Freetown Council on Aging/ Senior Center

Town of Freetown ADA Transition Plan

August 2023

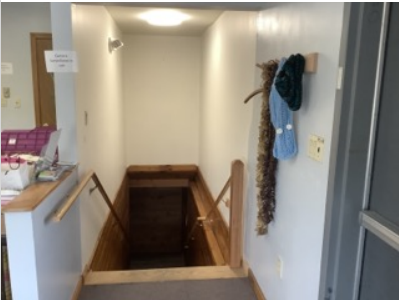
ID	Location	Floor	Room	Element	Type	Photo	Issues	Current Measure	Recommendations	Quantity	Price	Cost Estimation
Approach and Entrance												
Exterior Access Route												
1	Southwest Entrance/Exit to COA Office	Ext.		Exterior Access Route	Exterior		Obstructed by protruding objects	5"	Relocate light fixture out of the circulation path.	1	Labor	\$0
2	Pavilion Near West Side Parking Lot	Ext.		Exterior Access Route	Exterior		Does not prevent accumulation of water	-	Repair surface.	1	-	\$0
3	Garden Beds	Ext.		Exterior Access Route	Exterior		Accessible route not provided	-	Ensure an accessible route is provided to the garden beds.	1	-	\$0
4	Shuffleboard	Ext.		Exterior Access Route	Exterior		Accessible route not provided	-	Ensure an accessible route is provided to the shuffleboard court.	1	-	\$0
5	Horshoe Pit	Ext.		Exterior Access Route	Exterior		Accessible route not provided	-	Ensure an accessible route is provided to the horseshoe pit.	1	-	\$0

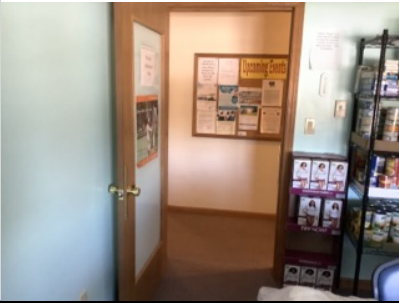
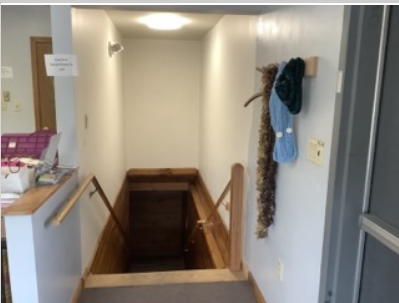
7	Northwest Space - West Side Parking Lot	Ext.		Off-Street Parking Lot or Garage	Visitor		Access aisle not provided Sign does not have the designation "Van Accessible" Surface not stable, firm, and slip-resistant	- - -	Provide a marked access aisle that is at least 96" wide. Add the designation "Van Accessible" to the sign located at the van accessible space. Ensure to clear snow from the accessible spaces.	1	800	\$800
Exterior Ramp												
8	Ramp to Northwest Side Entrance/Exit	Ext.		Exterior Ramp	N/A		No lower handrail 18"-20" high provided Running slope > 1:12 (8.33%)	22" 9.9%	Provide a lower handrail between 18" to 20" high above the ground or finished floor. Reduce running slope to be no steeper than 1:12 (8.33%). (Cost estimate based on a new 30' painted wood ramp.)	1	12067	\$12067
9	Ramp to Northwest Side Entrance/Exit	Ext.		Exterior Ramp	N/A		Handrails do not extend 12" past top & bottom Edge protection < 4" high	- -	Ensure that handrails extend horizontally above the landing for 12" min. beyond the top and bottom of ramp runs. Provide edge protection that prevents the passage of a 4" diameter sphere, where any portion of the sphere is within 4" of the finished floor or ground surface. (Cost included in ID #8.)	1	-	\$0

Exterior Stair												
10	Southwest Entrance/Exit to COA Office	Ext.		Exterior Stair	N/A		Handrails do not extend 12" from stair	-	Bottom: Ensure that the sloped bottom extension extends 12" plus the width of one tread beyond the bottom riser in same direction as stair flight.	1	1600	\$1600

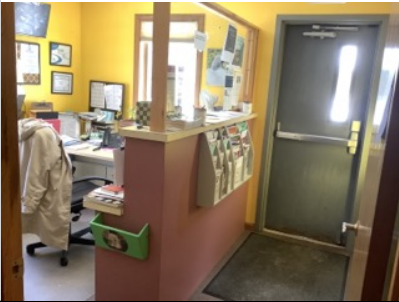
19	Northwest Side Entrance/Exit	2		Interior Access Route	292		Obstructed by protruding objects	-	Relocate defibrillator out of the circulation path.	1	Labor	\$0
20	Stair	2		Interior Access Route	N/A		Accessible vertical route not provided	-	Provide accessible vertical access. (Cost estimate is for a limited-use/limited-application (LULA) elevator between floors.)	1	90000	\$90000
